PPPO-02-1934964-13

TRANSMITTAL OF THE EXPLANATION OF SIGNIFICANT DIFFERENCES TO THE RECORD OF DECISION FOR THE INTERIM REMEDIAL ACTION OF THE NORTHEAST PLUME AT THE PADUCAH GASEOUS DIFFUSION PLANT PADUCAH, KENTUCKY, DOE/LX/07-1291&D1

Explanation of Significant Differences to the Record of Decision for the Interim Remedial Action of the Northeast Plume at the Paducah Gaseous Diffusion Plant Paducah, Kentucky

Date Issued—June 2013

Figure 5. Locations of New and Preexisting EWs Associated with the Northeast Plume IRA at PGDP

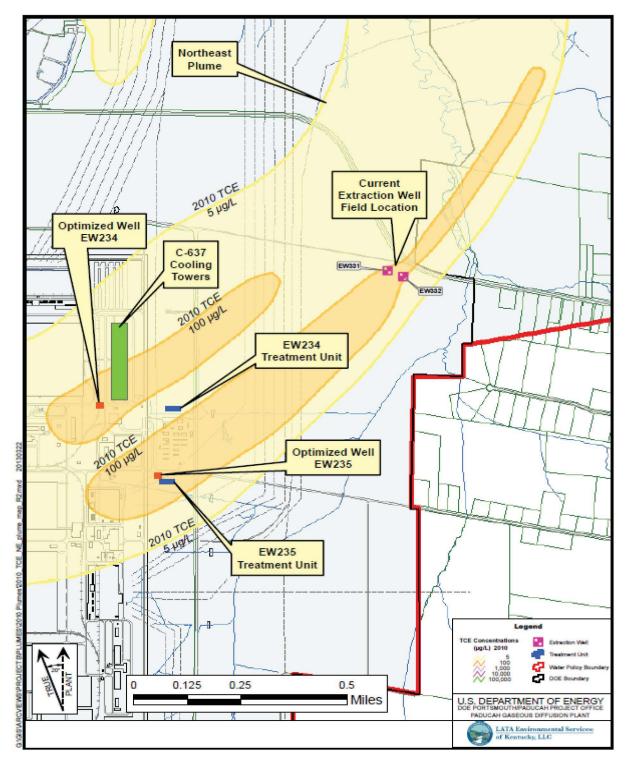
- Northeast Plume EWs will be located near the eastern edge of the PGDP and the existing EWs (EW331 and EW332) were to be taken out of service.
- Use of the PGDP cooling towers for stripping TCE and 1,1-DCE will be discontinued and will be replaced with engineered water treatment units that utilize air stripping for TCE and 1,1-DCE contamination.
- Treated water discharge will be through a maximum of two CERCLA outfalls.
- A new non-USEC electrical power connection will be installed for the treatment units and EWs.

Well field optimization modeling indicates that a two-well configuration is optimal. The two new wells, EW234 and EW235, are to be located near the eastern edge of the PGDP facility. Refer to Figure 5 for well locations. The EWs are expected to have an operational flow rate of approximately 150 gpm each. Detailed lithologic logs and grain size analysis to the extent available will be used in well screen and filter pack design of the new EWs.
